2100 QUEEN ANNE AVENUE N

SDCI# 3034141-LU
DESIGN RECOMMENDATION MEETING #2
2/3/2021

POST DRB COMMUNITY FEEDBACK

I.ii - NORTH & SOUTH STAIR BAY STUDY

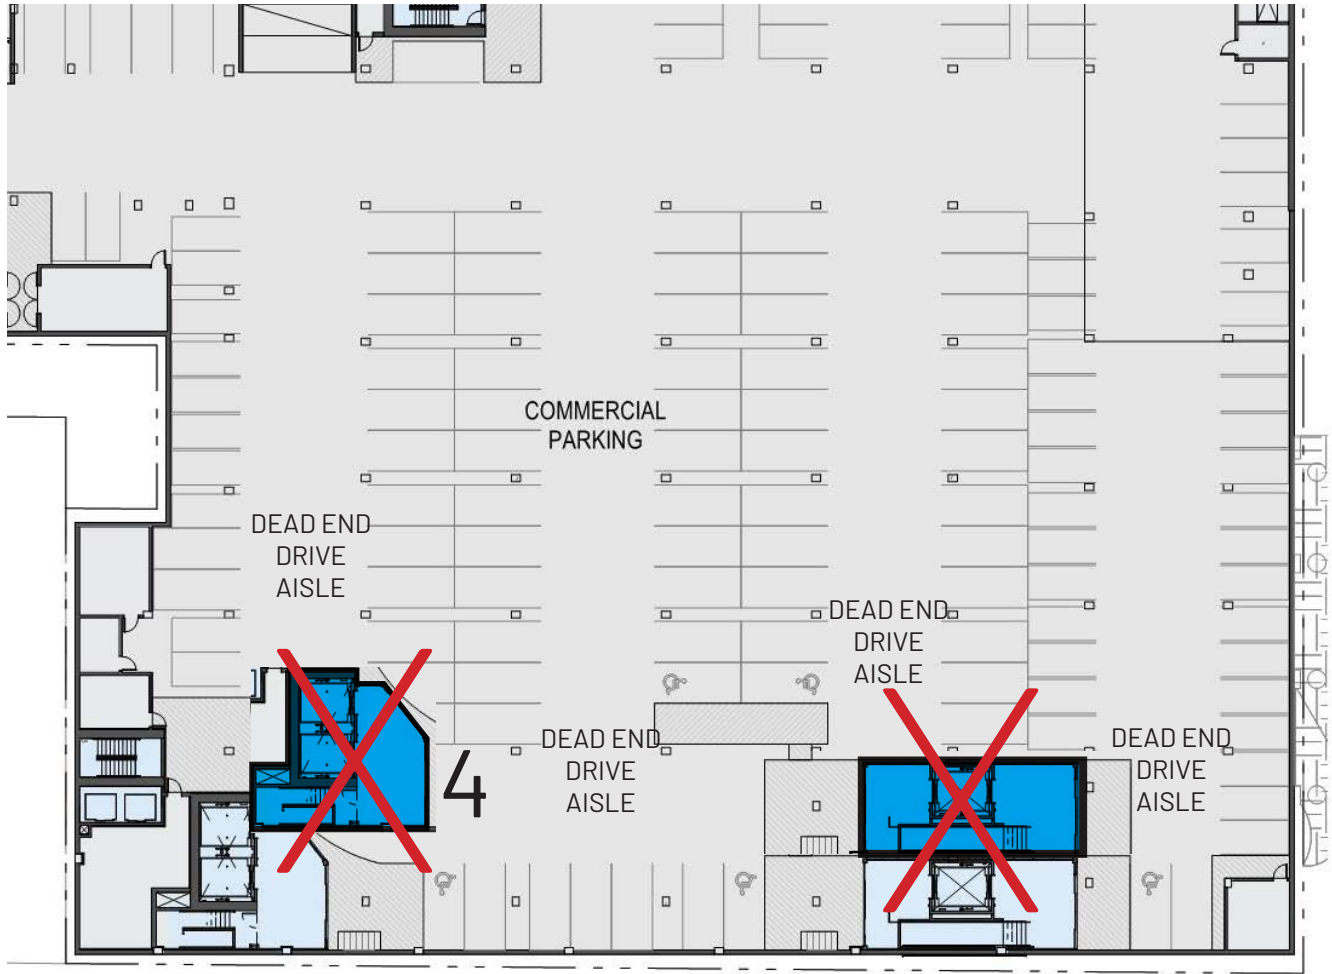
- 1 Level 1:
Truck loading cannot shift
- 2 Grocer Function - main stairs & elevators cannot be on the interior of the store due to theft. Elevators & stairs are on the street side of the cashiers.
- 3 Fire & Life safety requirements - the two stairs must exit directly to the exterior

- 4 Level P1:
The grocer parking requires maintaining drive aisles that do not dead end to avoid having people backup. Moving the stairs inboard would create dead end aisles. This is not preferred for commercial public parking where people do not have assigned parking.

The sidewalk experience at the south stair bay will include an integrated lean rail for people to use while waiting for the bus. A continuous canopy will provide weather protection. A door will be provided for easy access to the Starbucks, and a vibrant mural at the stairs & elevators will provide a backdrop to people entering the store from the parking garage via the stairs.

I.iii - POTENTIAL SECOND RETAIL SPACE WITH SAFEWAY STUDY

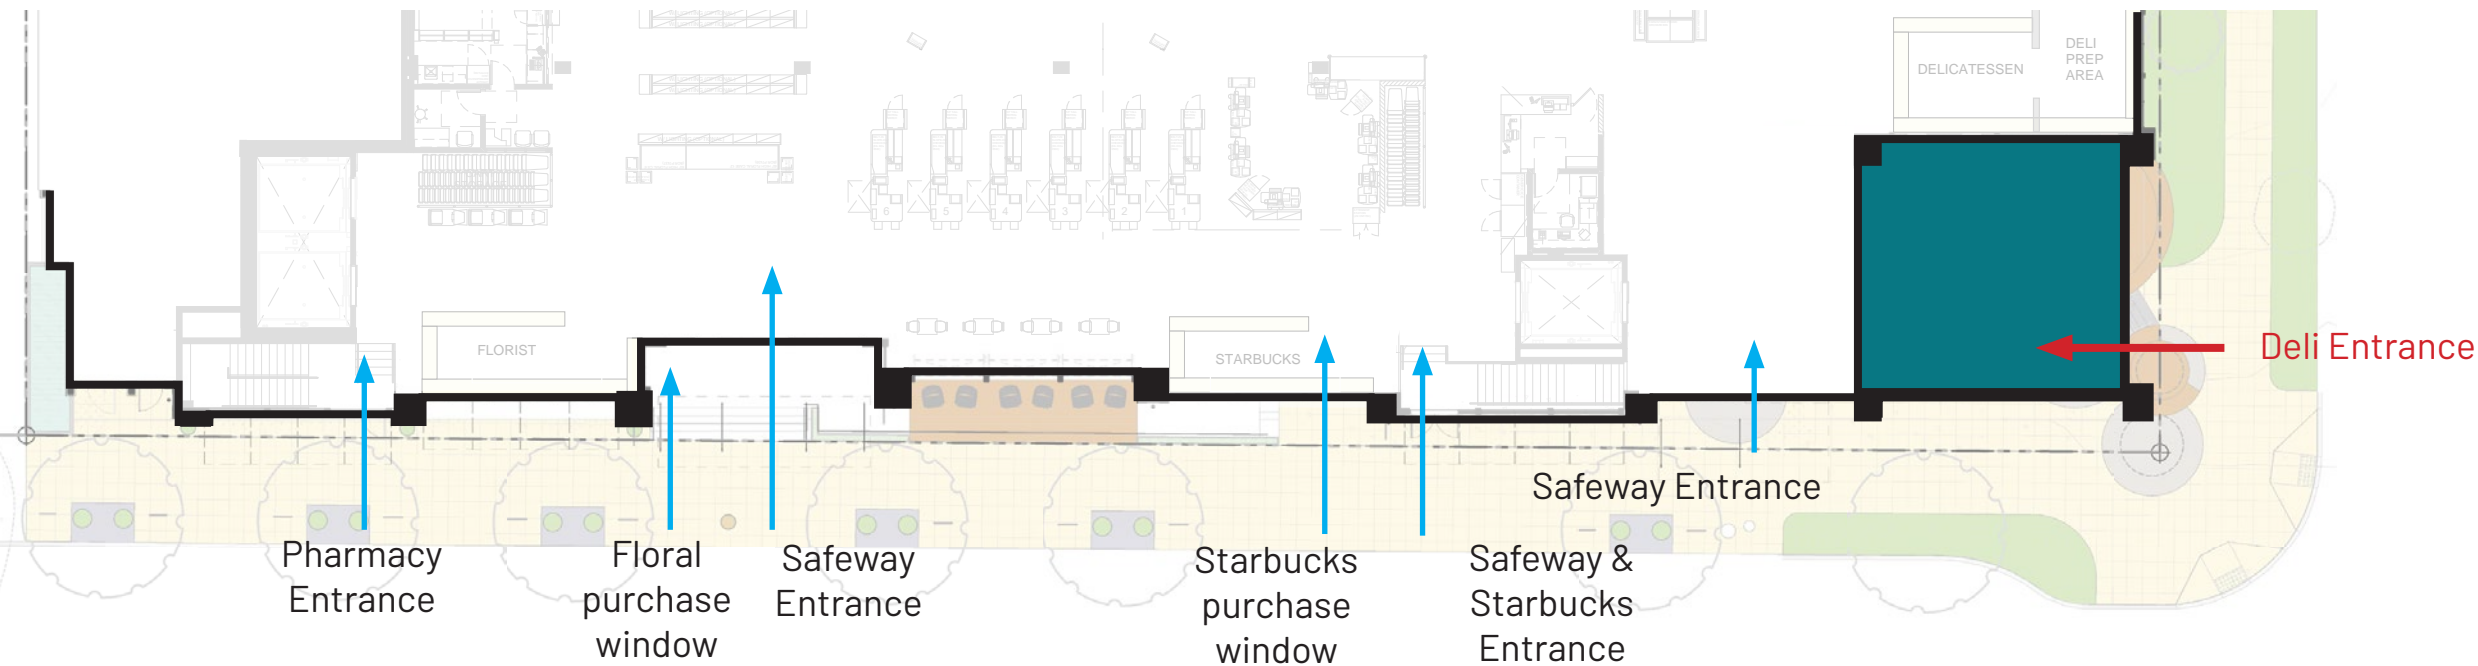
- a. The Board asked to see studies for adding small commercial spaces on Queen Anne Avenue (CS2-B, CS3, CS3-II-iii.)
The Board asked for further evolution of the storefront design to sufficiently respond to the context shown in the EDG & Design Guidelines. (CS2-B, CS3, PL3, DC2)
- b. The Board also noted that the stair bays would not provide the activation with the street (CS2-B, CS3, PL3). The Board noted that they may be open to some reduction of active uses so long as the overall street frontage is designed to respond to these initial recommendations & Design Guidelines. (CS3, PL3, PL3-I, DC2-I)

Study analyzing potential additional independent retail store

The new Safeway urban store program will require the 50,000 sf allowed by the zoning code. This new grocery will include additional amenities now found in modern urban grocery stores such as expanded deli with a variety of take out foods and indoor seating. In order to accommodate the 1 small commercial space and an urban grocery store, the large corner plaza that provides seating areas for the neighborhood would be replaced by the small retail space. The applicant's preferred design, as presented at the DRB meeting on 12/2/20 better meets design guidelines by providing a highly activated frontage along Queen Anne, including a large south facing plaza that will provide public seating, public art, and a children's play area.

I.iv - POTENTIAL FUTURE SUBDIVISION OF RETAIL STUDY

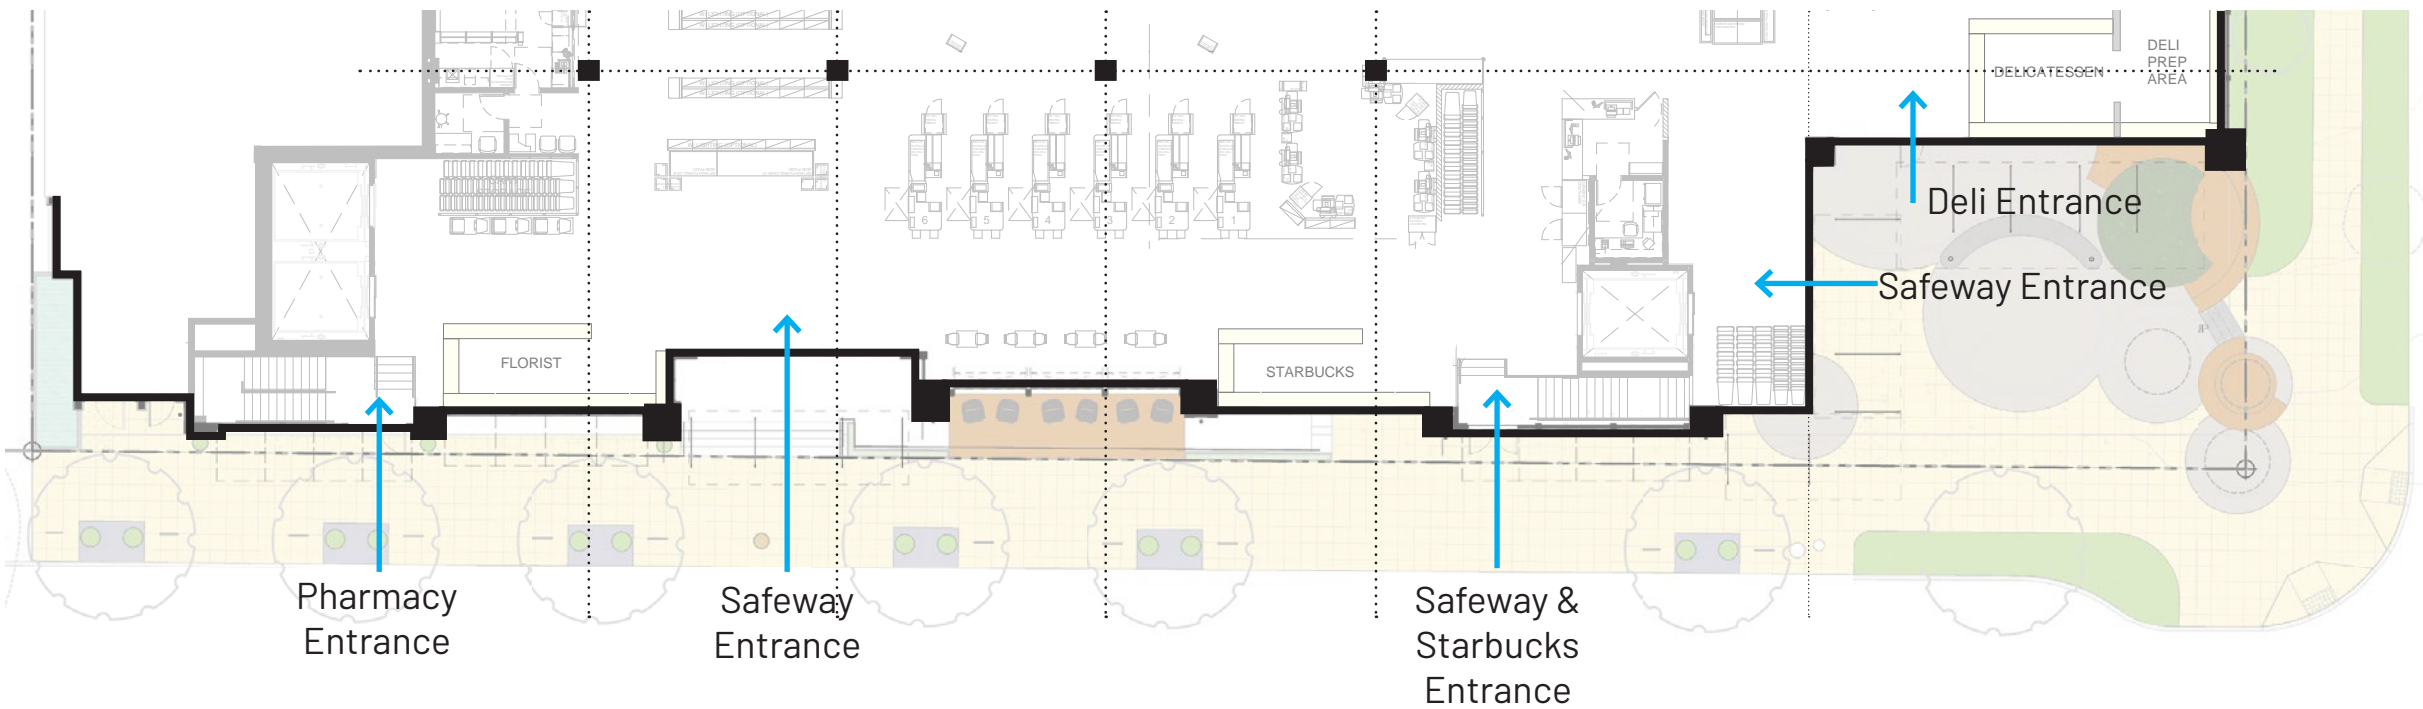
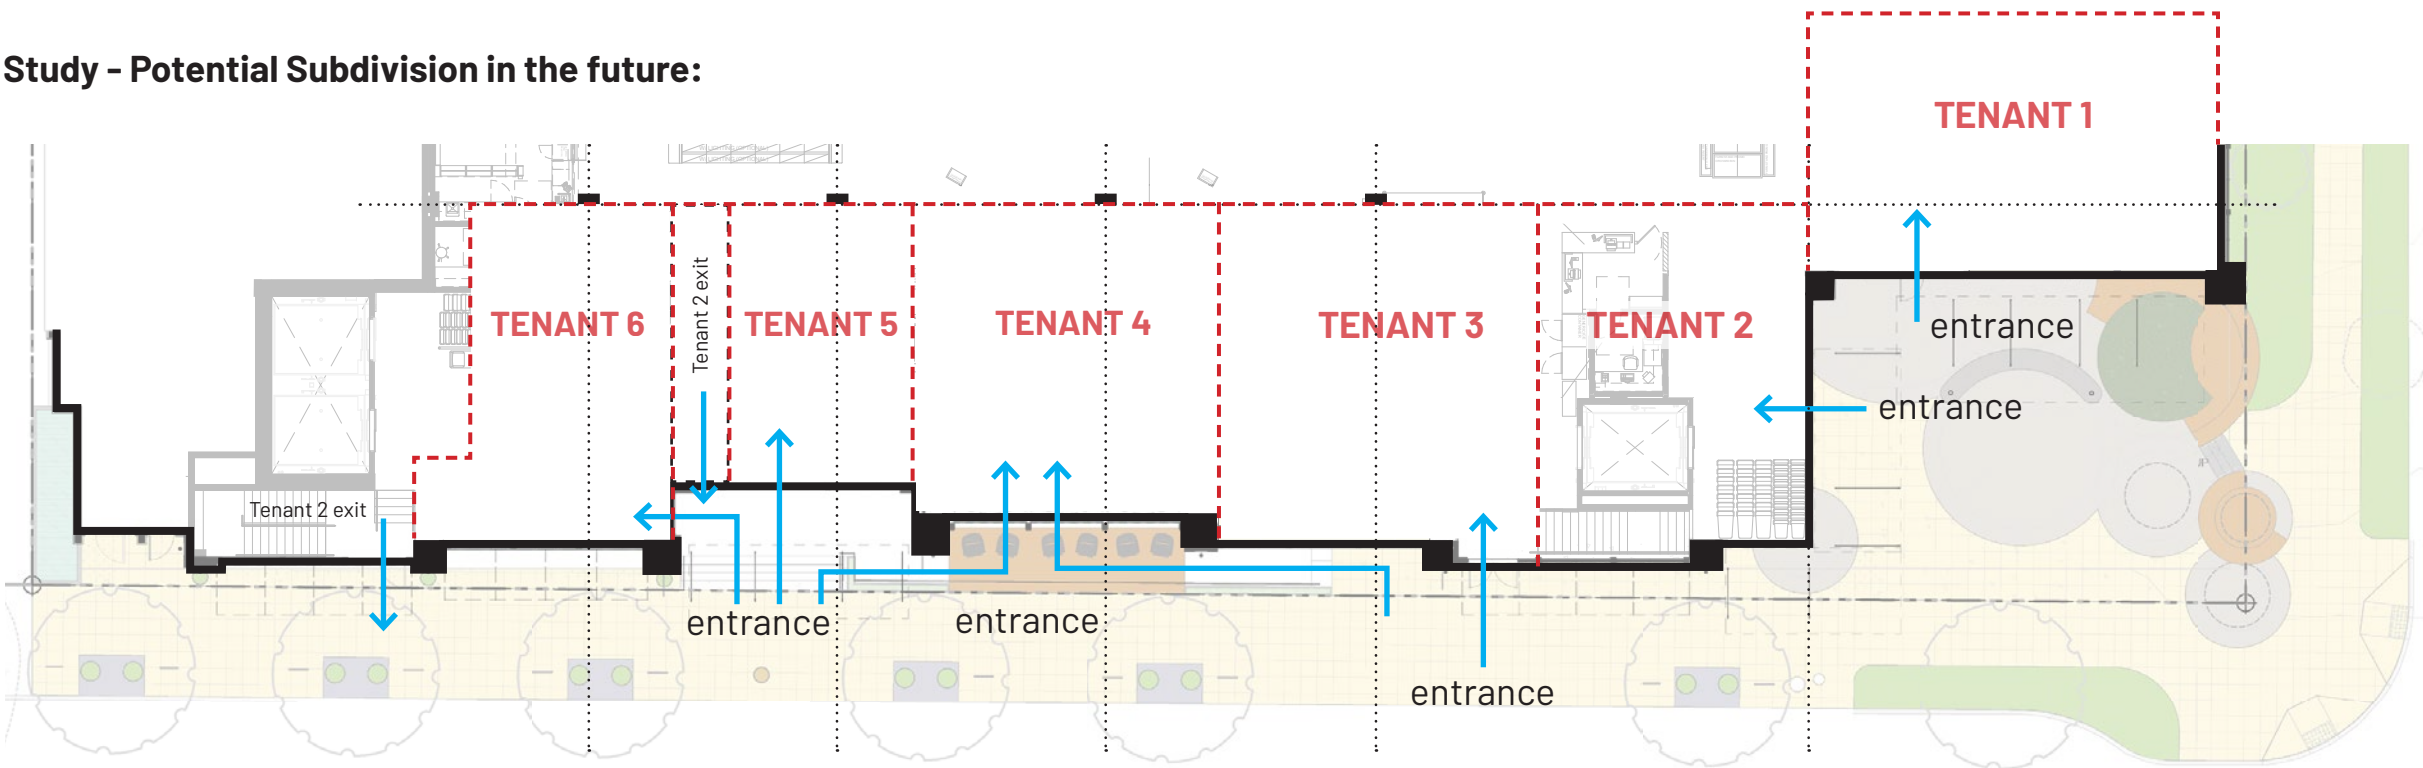
- a. The Board was divided on the question of whether the proposed single commercial use with exterior features that appear to be independent retail spaces could successfully meet guideline criteria. The Board noted that fewer than the required eight individual retail spaces could meet the Design Guidelines, if they were designed carefully to respond to the Design Guidelines. (CS2-B, CS2-II-I, CS3, PL3, DC2)
- b. The Board agreed that if independent retail spaces were not provided, that additional development would be required to further differentiate and break up the street front facade, creating additional variety in scale, materials, detailing and architectural expression at the street edge. (CS2-B, CS2-II-I, CS3, PL3, DC2)

Study analyzing the potential to subdivide the spaces into a series of small retail spaces if needed in the future. The study uses the existing column grid and locations for Accessible entries to show how 5 small commercial spaces could be demised in the future along the Queen Anne frontage.

BAY STUDY 4 - EXTENDED WOOD-COLORED SPANDRELS AT CORNER

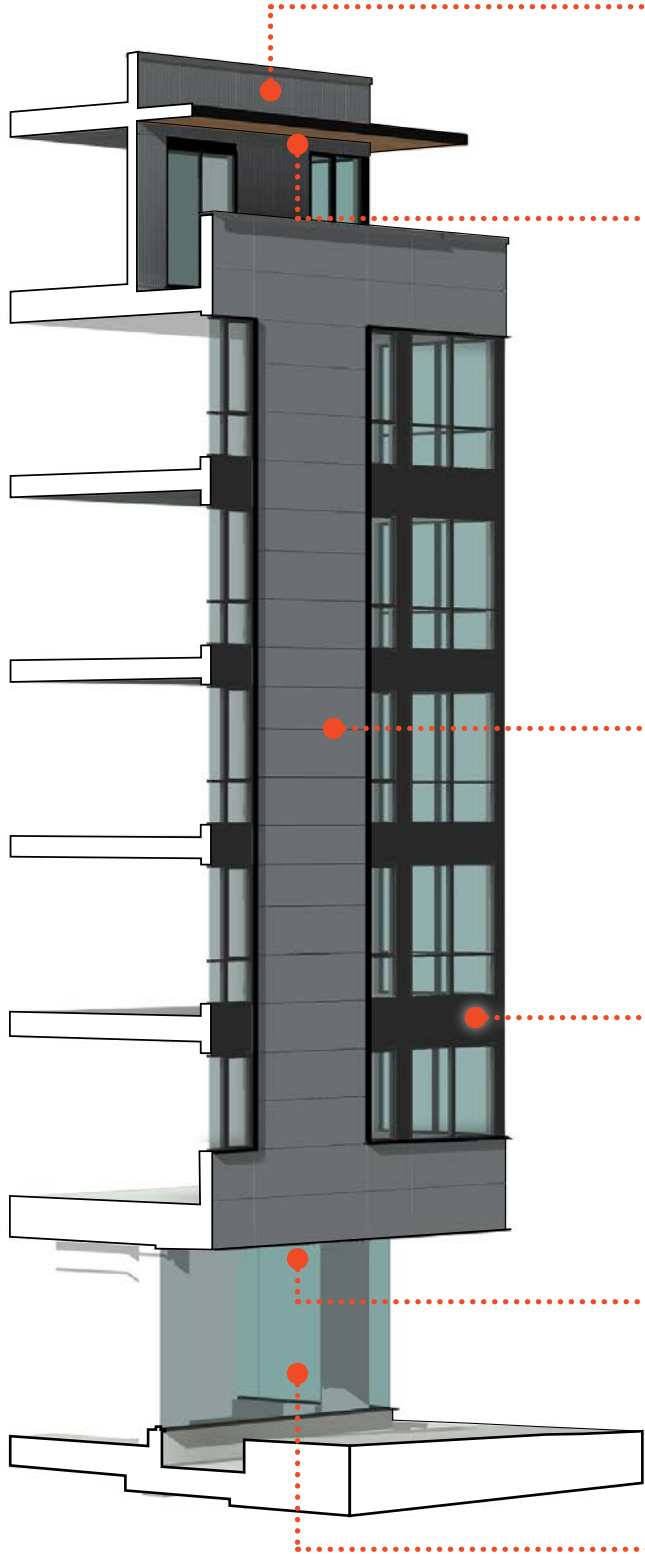
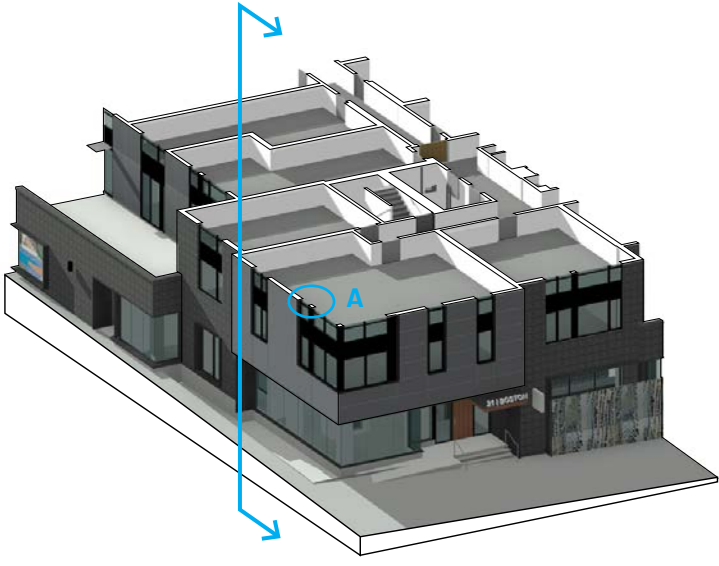
- i. Study analyzing more color for Building A corner bay
- ii. Diagrams clarifying depth of cladding and “fine grain detail”
- iii. Diagram clarifying vents for Building C
- iv. Study analyzing potential balcony locations for Building C

RESPONSE:
A series of studies show how Building A corner bay could have a warm color introduced to the corner. The applicant team still prefers the Baseline Option because it best reinforces the massing concept. An overarching design goal for this project is to avoid a busy building with lots of moves that create visual noise. Instead, we propose a clean, elegant residential building with attention to the detailing. The goal is to concentrate the color and life to the ground level (colorful murals, signage, highly transparent glazing). The added detail found in the enlarged section and plan detail further illustrate the proposed condition.

APPENDIX 2 - EDG RESPONSE 4B - MULTIPLE ENTRANCES ALONG THE QUEEN ANNE FRONTAGE

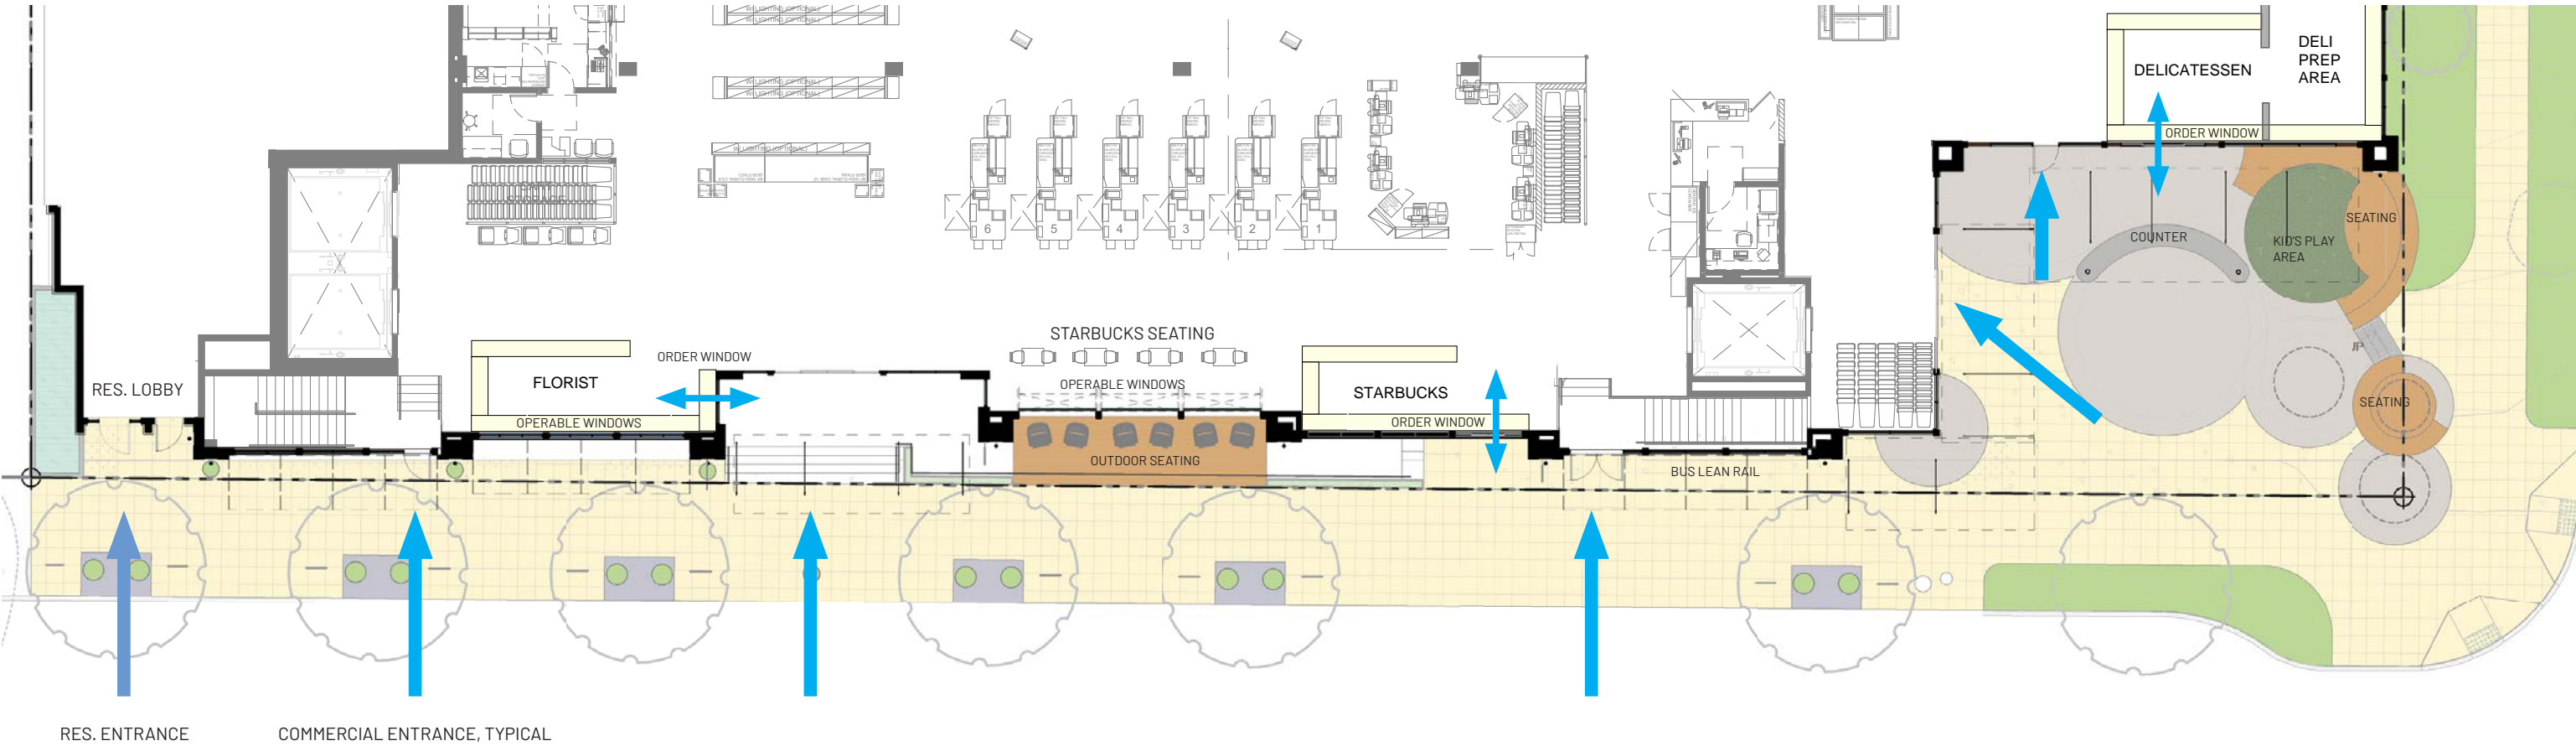
4b Multiple entrances along the streetscape - The Board agreed that a critical component in creating a vital urban environment that fosters human interaction was the porosity of the street edge. The board noted that extensive glazing could contribute to this but citing several unsuccessful recent examples, agreed that multiple additional entrances could likely be required along this extensive street front.

In response to community and EDG board comments, there are now 4 doors and 3 walk-up counters on the Queen Anne frontage to provide multiple opportunities for pedestrian and shopper interaction with the retail uses along the sidewalks.
